Re: I-70/Harvest Road Interchange 1601 Application

In response to your letter, dated March 2, 2020, we offer the following initial responses to the items CDOT requested be addressed to facilitate an efficient 1601 process:

Attachment A - *"I-70/Harvest Road Interchange Construction Information Exhibit"* for additional information.

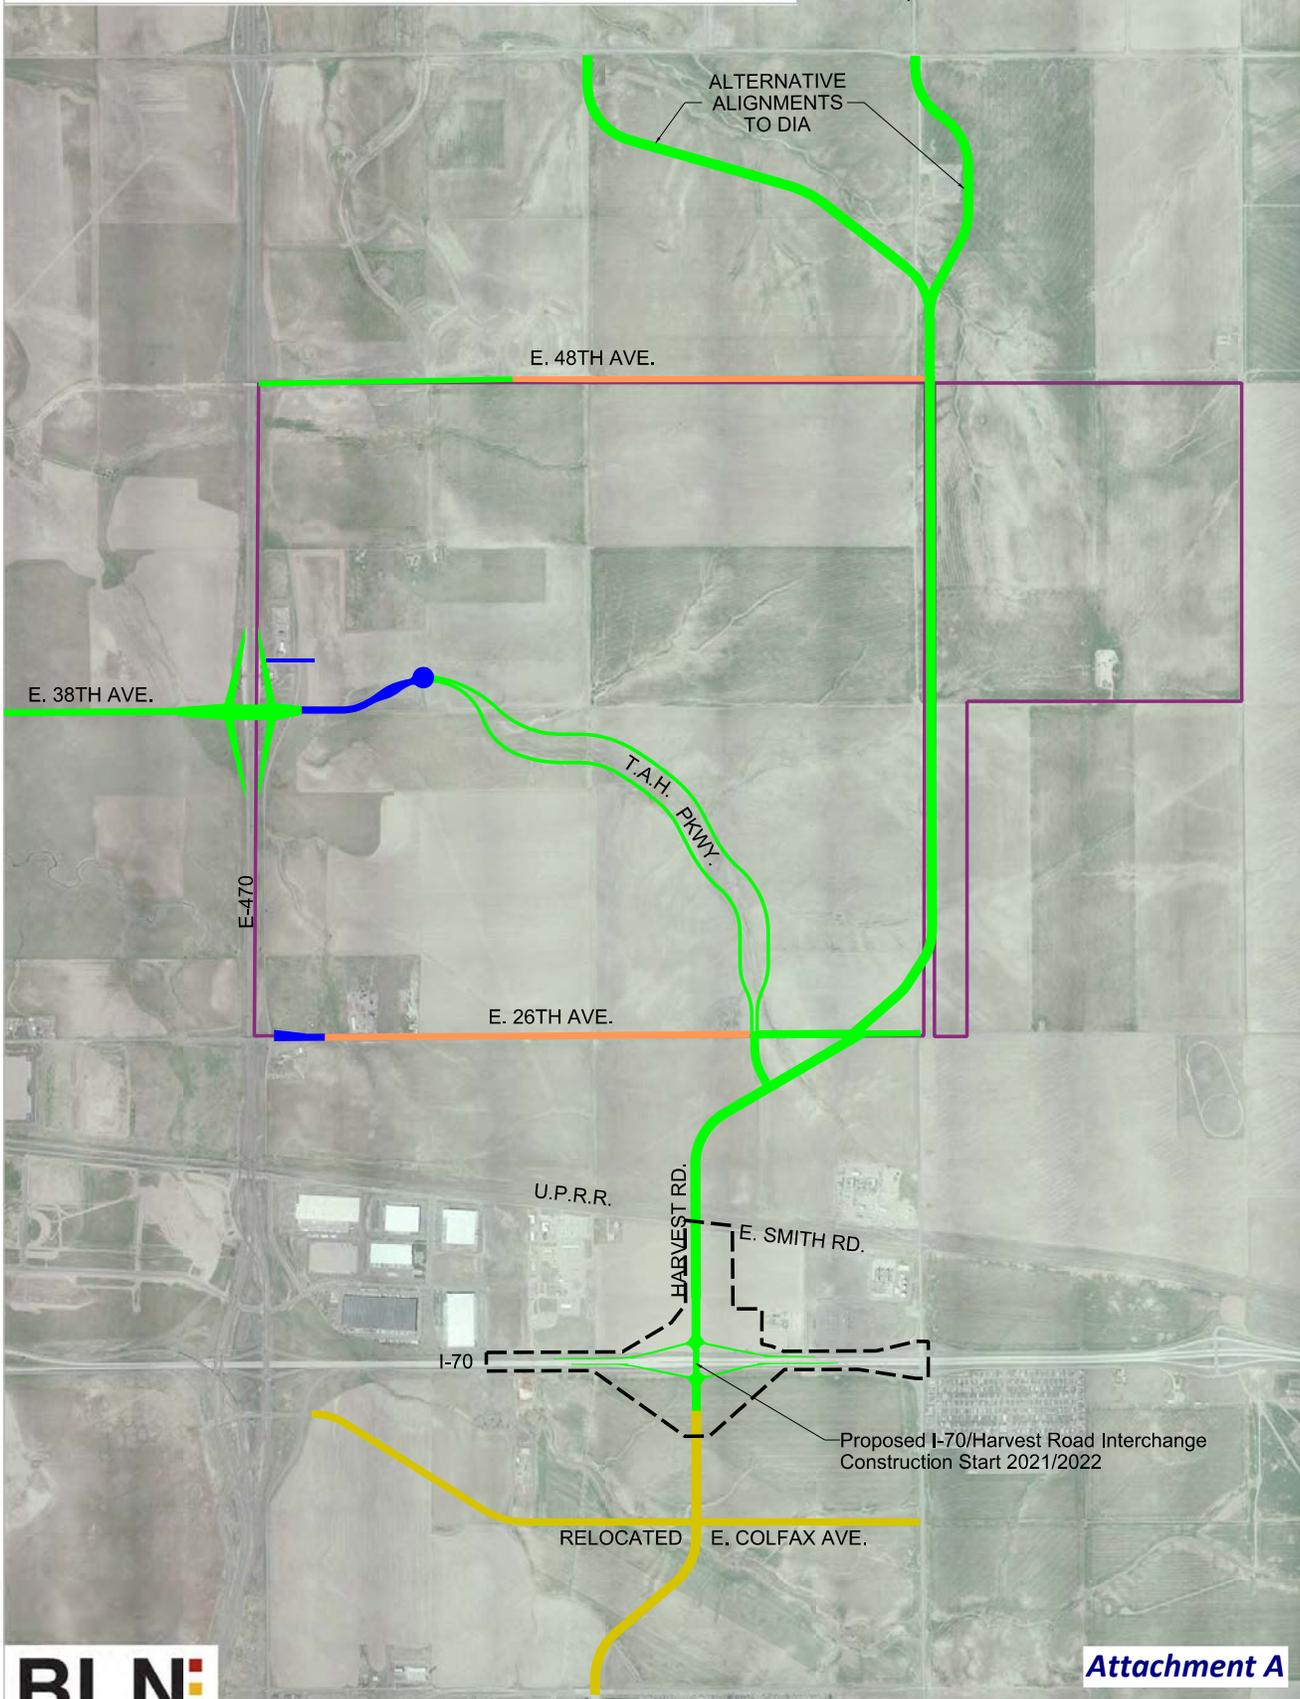
- *Traffic numbers used for new interchange were based on the DRCOG 2040 model, which includes construction of a future roadway system (parallel network). CDOT requests a plan from ARTA as to when the system will be constructed and what triggers will be in place for the system to be constructed.*

The traffic forecasting for the proposed interchange has utilized the most current version of the DRCOG activity-based travel demand model (Focus 2.2) which also takes into consideration the recently updated North East Area Transportation Study, dated October 2018 (NEATS Refresh). ARTA is responsible for the funding, design, and construction of a portion of the future roadway system included in the DRCOG model and the NEATS Refresh (the NEATS Refresh is available for reference on the City of Aurora website). The overall roadway network will be triggered by travel demands as development occurs along the Harvest Road corridor and will be controlled through the City of Aurora and Adams County development approval processes along with referrals to CDOT.

The initial construction of roadways associated with the interchange for which ARTA is responsible are identified and projected to be constructed as follows: Initial Harvest Road Interchange construction 2022 with links to existing Powhaton initially and connection to Harvest Road/Powhaton roadway north of I-70 in 2022-2024 timeframe. Please refer to

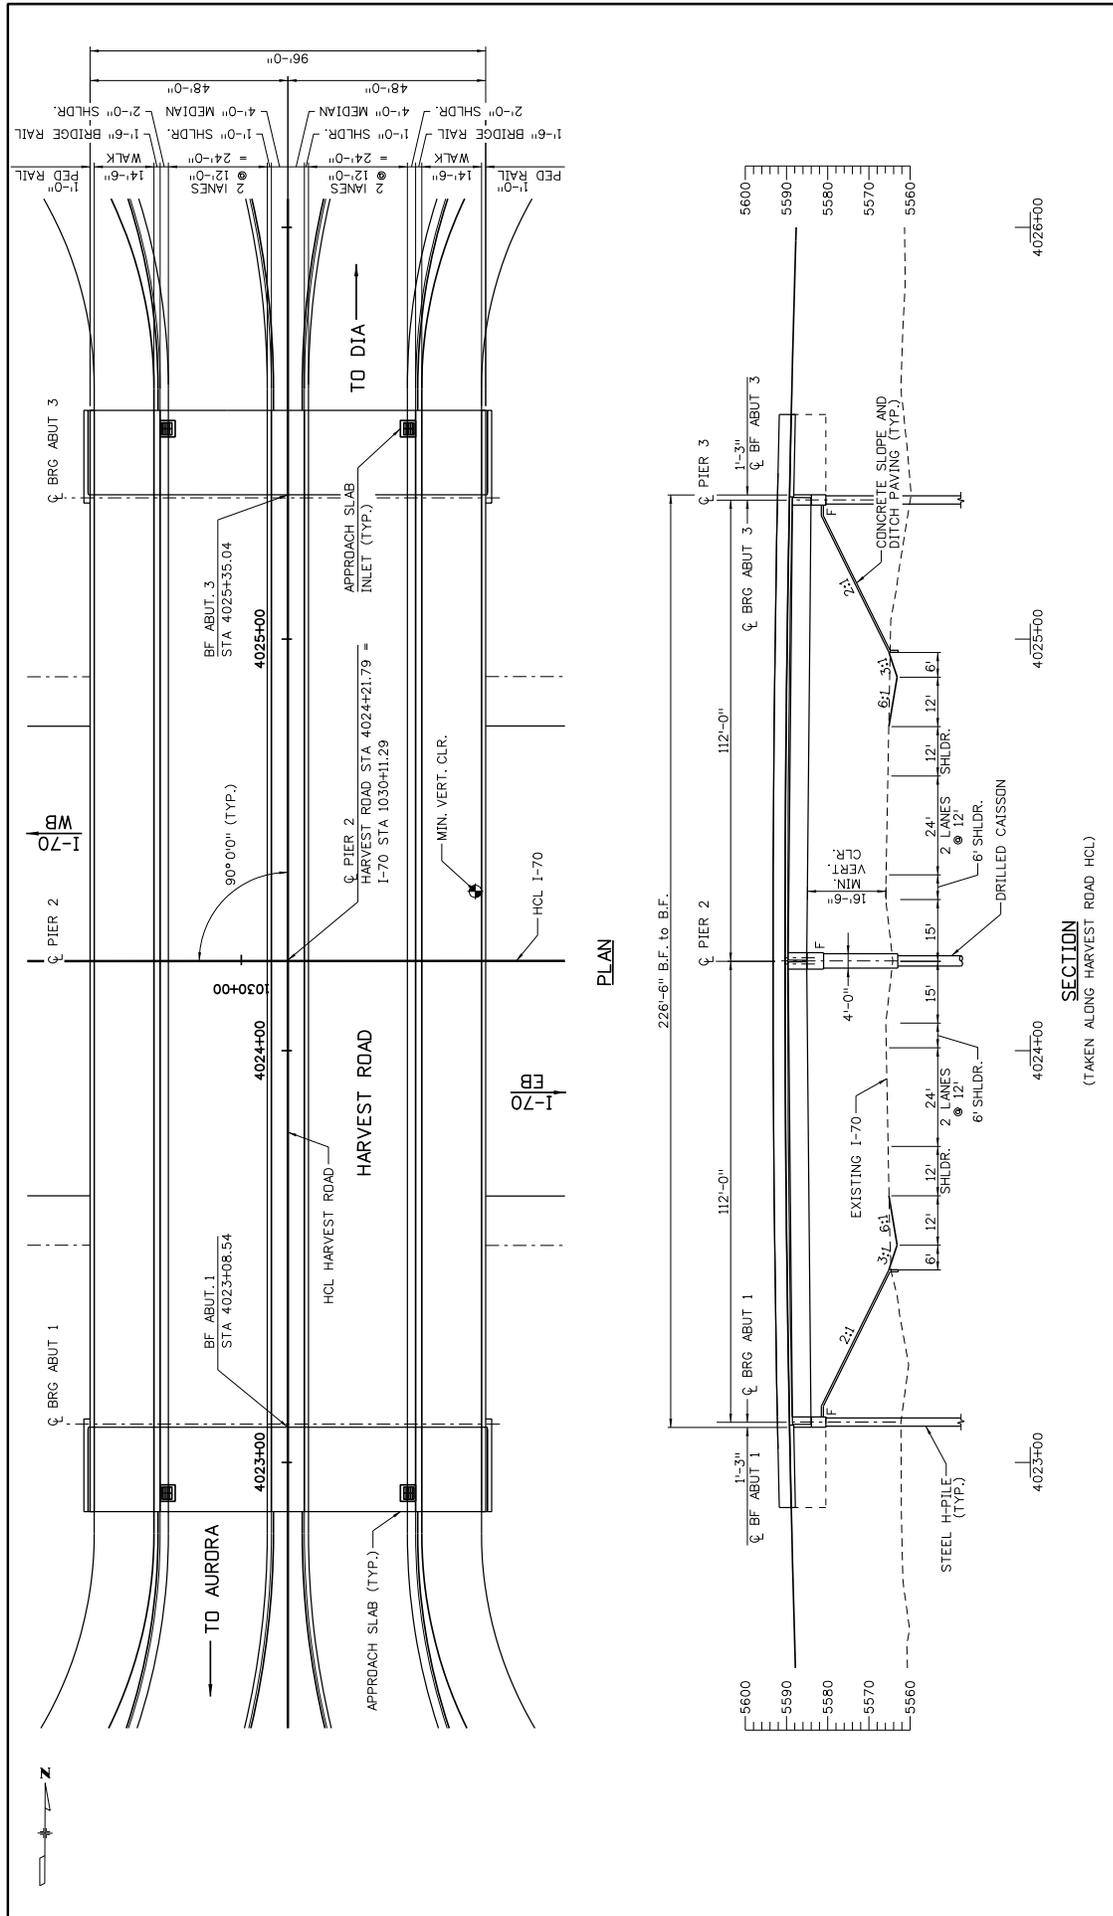
- *CDOT requests enough clear span to allow for a future I-70 footprint similar to I-25 and I-70 in metro Denver. At a minimum two 101 foot clear spans, totaling 202 feet is requested for the Harvest structure over I-70.*

The future needs and demand for I-70 have been anticipated in the preliminary span layout for the Harvest Road bridge over I-70. The minimum span lengths requirement for the future I-70 lane configuration has been accommodated in the preliminary bridge layout and ramp spacing. Refer to Attachment B - *"I-70/Harvest Road Interchange General Layout"* for more information.
